66321D-09

S E R V I C E N O T E

66321D – Mobile Communication DC Source, 15V/3A with Battery Emulation. GPIB

Power-On Self test Errors, Auto reboot, Blank display. No output Communication errors. No communication when using the GPIB Interface.

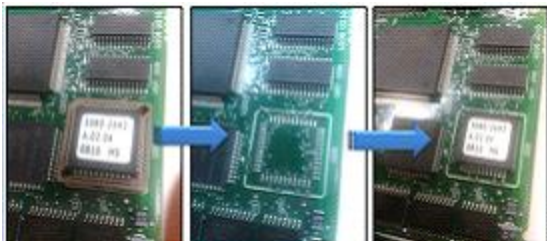
When the EEPROM is installed in the PLCC SOCKET (**Circuit Reference U205**) on the Interface board if there is not a gas tight connection between the EEPROM pins and the socket pins an intermittent connection will occur.

It has been determined when removing the socket and soldering the EEPROM (circuit reference U205) directly on the interface assembly “A2” would be very difficult (See Picture below), even having the correct tools, removal of the socket and replacement of the EEPROM is very difficult and may cause additional quality and reliability issues.

1. The problem can be solved by replacing the GPIB Interface assembly. See above for the tested interface P/N that is required to repair the instrument. The correct tested assembly for the specific model must be used when repairing a defective instrument.
2. This problem can also be solved by removing the socket (circuit reference U205) on the “A2” interface assembly and soldering the **Original** EEPROM directly to the Printed Circuit assembly
